Record of Technical Discussions  
on the Basic Design Study  
on the Project for Improvement of Security Facilities and Equipment  
in Sihanoukville Port and Phnom Penh Port  
in the Kingdom of Cambodia

## Record of Technical Discussion

**Minutes of Discussions  
on the Basic Design Study  
on the Project for Improvement of Security Facilities and Equipment  
in Main International Ports in the Kingdom of Cambodia  
(Explanation on the Draft Report)**

Figure 3-1

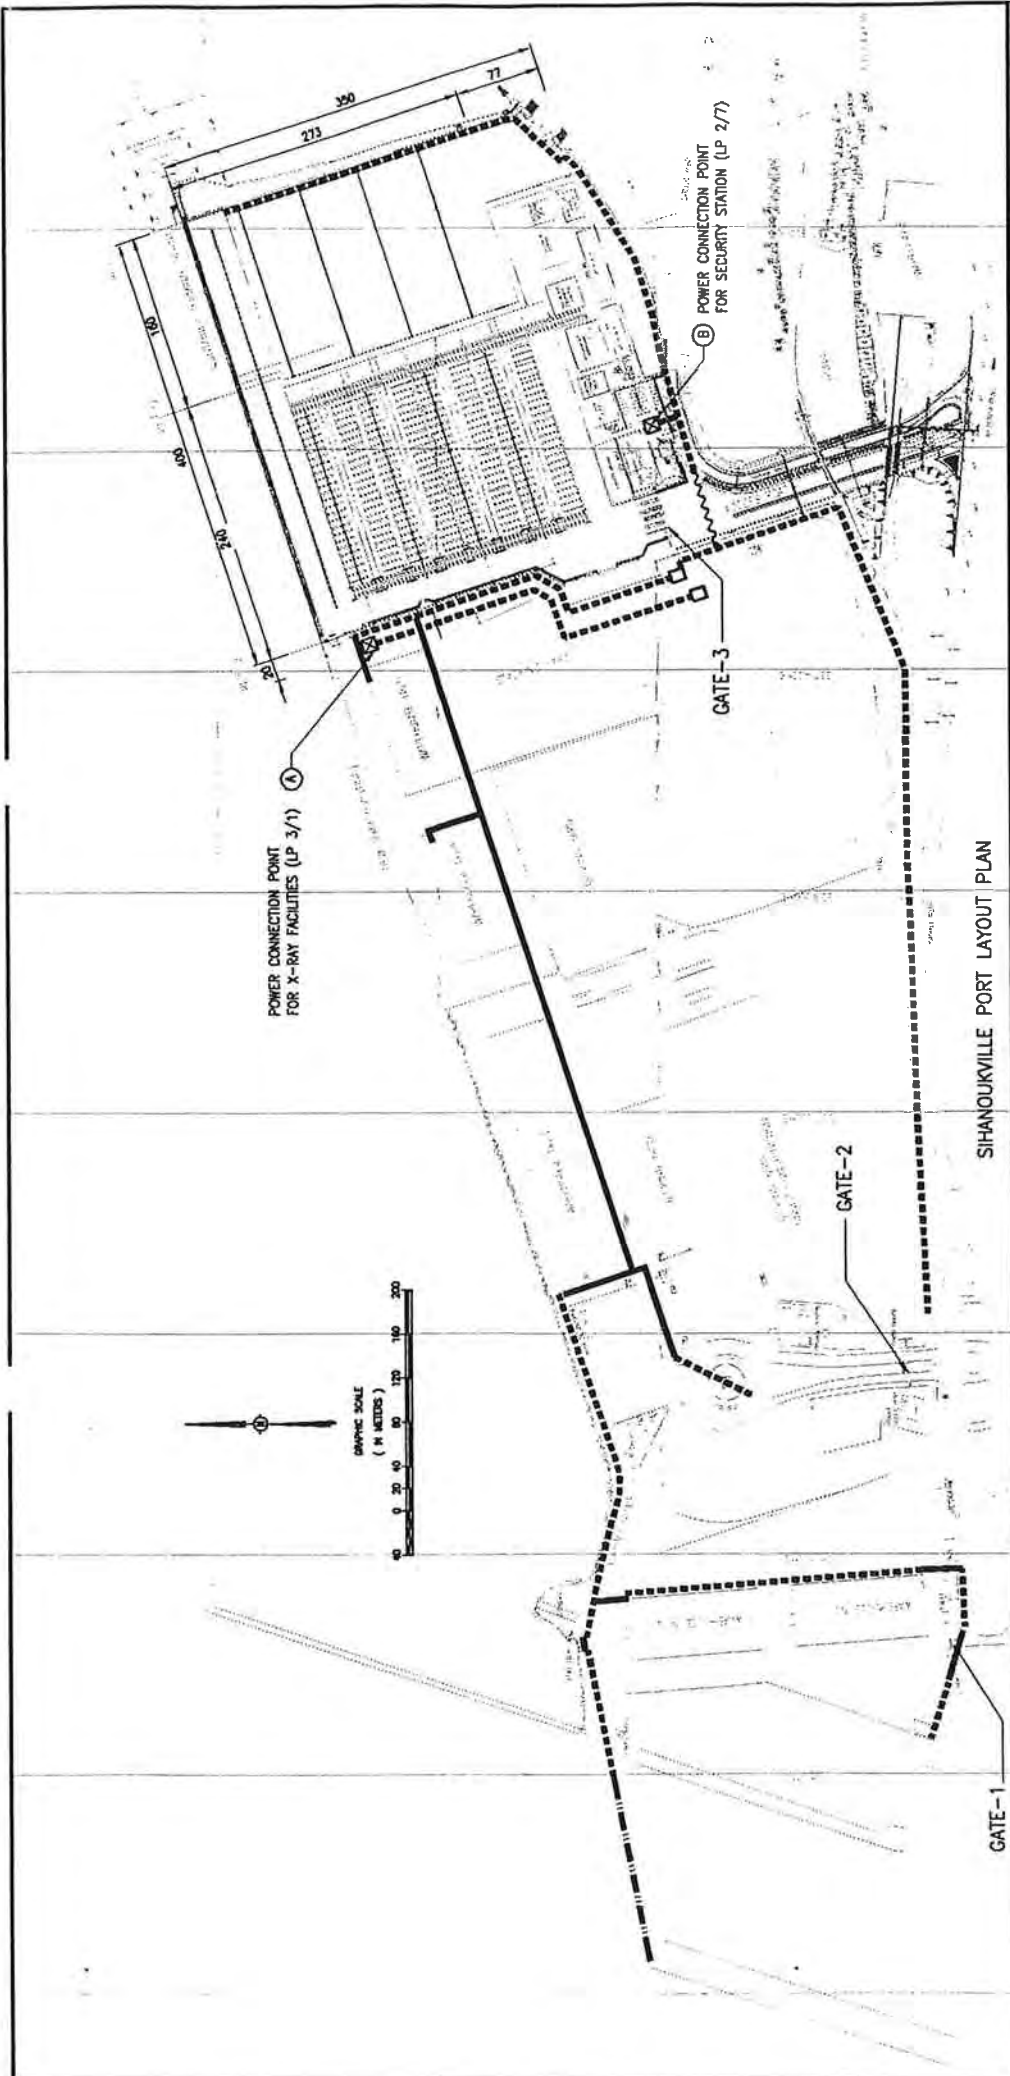
- Camera max. visibility of 350 m will be adopt.
- Color camera night time visibility is obtained by 1.0 lux illumination.
- Power consumption of camera is 18 watts(approx.) per 1 no.
- Ambient operating temperature is plus 50 degree at continuous operation mode.
- Two types of camera will be employed.
  - Outdoor pan/tilt camera(for yard surveillance)
  - Outdoor fixed camera(for gate surveillance)
- Team explained to the PAS, installation plan for gate and yard surveillance CCTV cameras (see, Figure 3-1).

Fig. 4-1

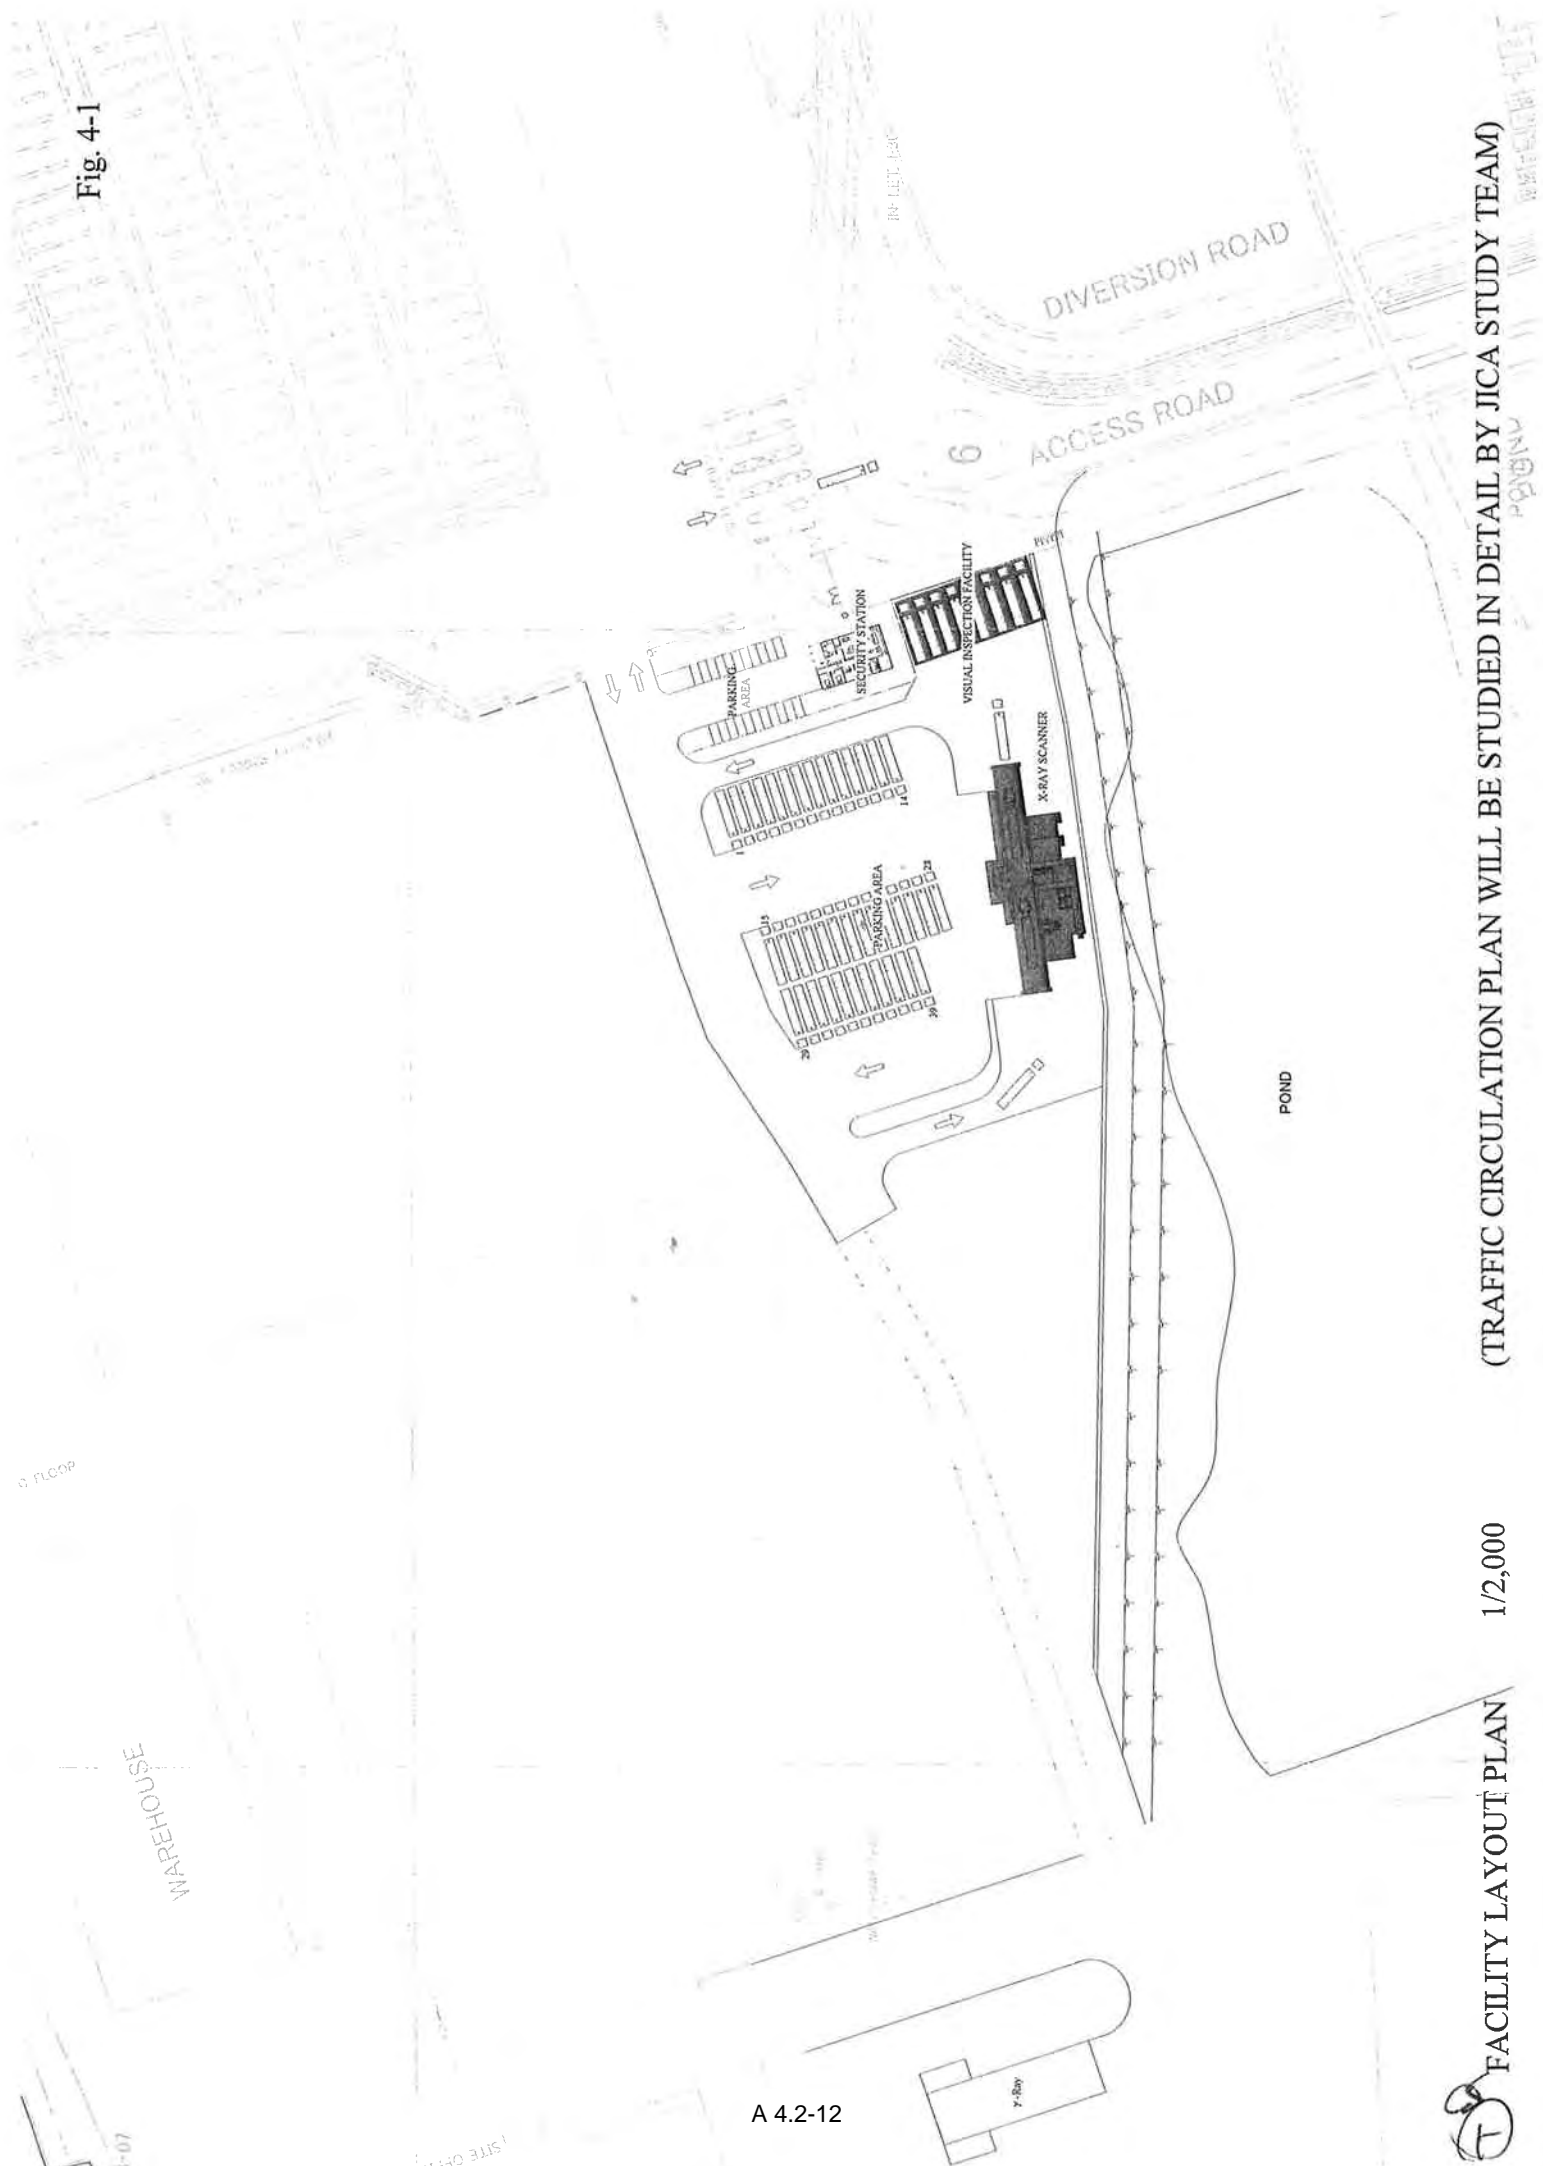
- Team studied the circulation plan for the import and export containers. Based upon the plan, Team discussed with the Cambodian side, and proposed a draft plan. The Cambodian side understood the plan.
- Cambodian side requested Team to study the container's circulation in detail in order to avoid traffic congestion.

Team discussed with Cambodian side regarding the location of security station and components of the facility. Cambodian side requested to locate it on the side of the container gate. Team studied the appropriateness of the location, and proposed a facility plan. The plan was accepted by Cambodian side, and Team makes a draft final plan based on the study after return to Japan.

Fig.5-1

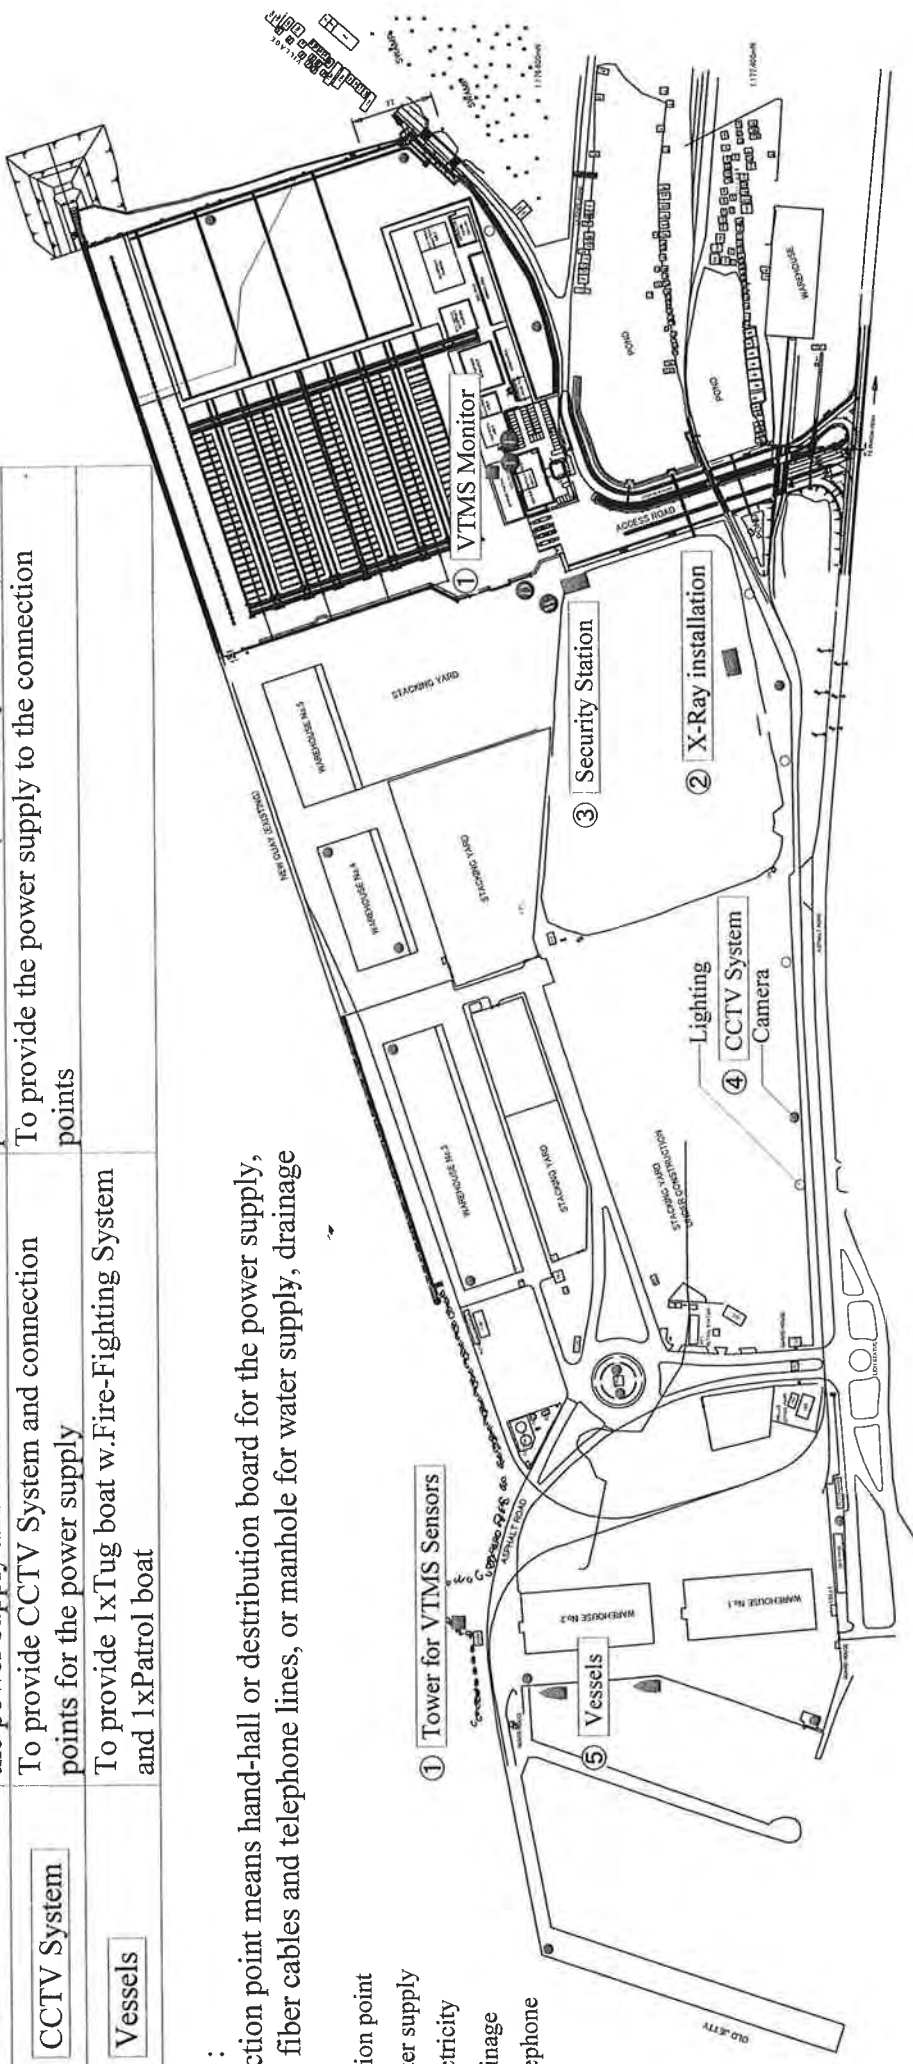
Team discussed with Cambodian side regarding demarcation of undertakings by Japanese side and Cambodian side. Cambodian side understood the principal of JICA Grant Aid system. Team confirmed that Cambodian side shall provide utility lines such as water-supply, drainage, electricity and telephone to the connection points for the facilities.

Final demarcation of undertakings will be defined by JICA based on the result of analysis.

TENTATIVE LAYOUT PLAN

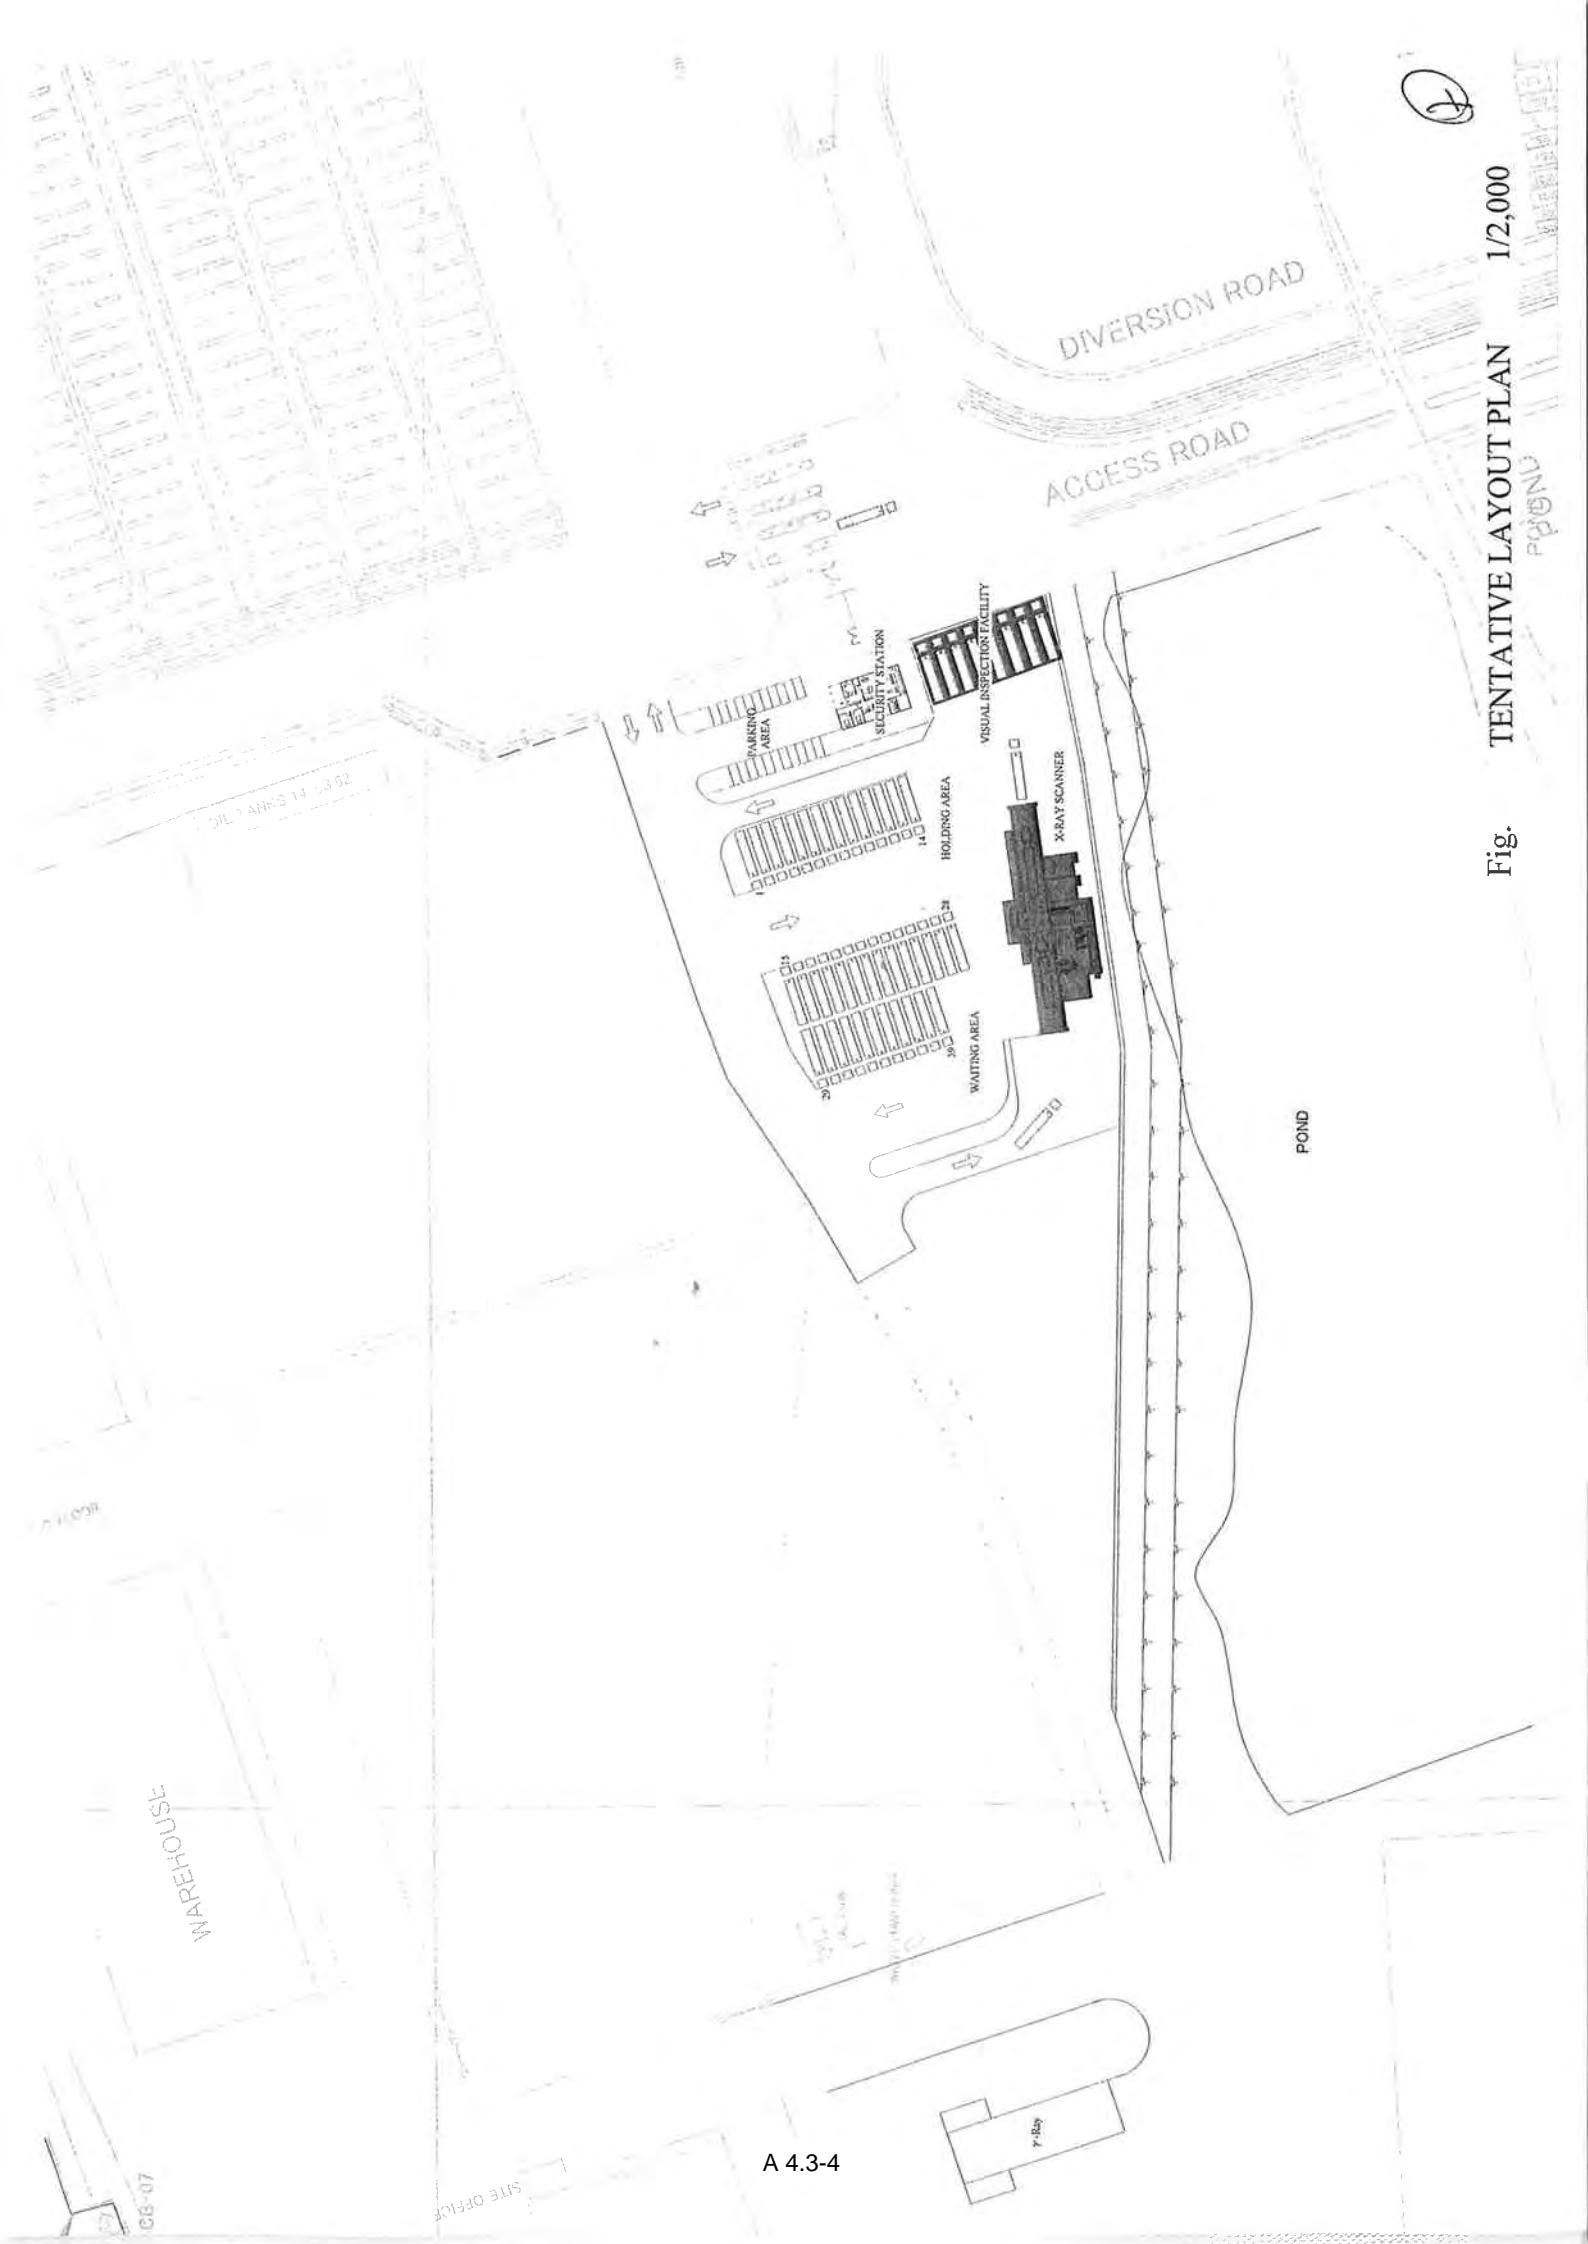
- (1) Newly installed X-ray scanner should be located considering the traffic line of container in the Port (See Fig. Tentative Layout Plan).
- (2) Appropriate scale of covered facility for the physical inspection should be provided as a part of X-ray Container Inspection system for quick and efficient inspection activities.
- (3) Adequate backyard area for export/import container trailers for X-ray inspection should be provided.
